UNITED STATES PATENT AND TRADEMARK OFFICE

Office Action Summary

10/510,384

DETAILED ACTION

Figure 1 (Modified from '380)

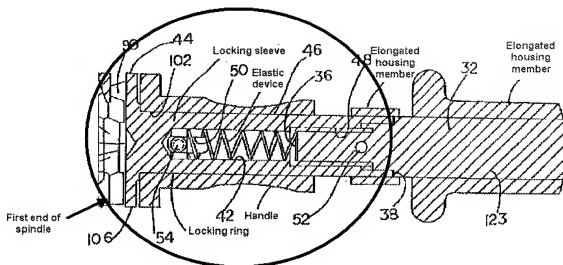
Salyer et al. disclose an elongated surgical reamer spindle, e.g. 10, having first and second ends and a central housing enclosing a drive train and comprised of at least two elongated housing members (see figure 1 below) a locking ring (46), an elastic

device (58), a locking sleeve (18), having a handle (24), and recesses, and a surgical reamer, e.g. 78 (see figures 1-19).

Applicant's arguments filed September 15, 2007 have been fully considered but they are not persuasive. Applicant argues that Salyer et al. does not disclose at least two elongated housing members. Figure 1 above, taken from Salyer et al., shows two elongated housing members.
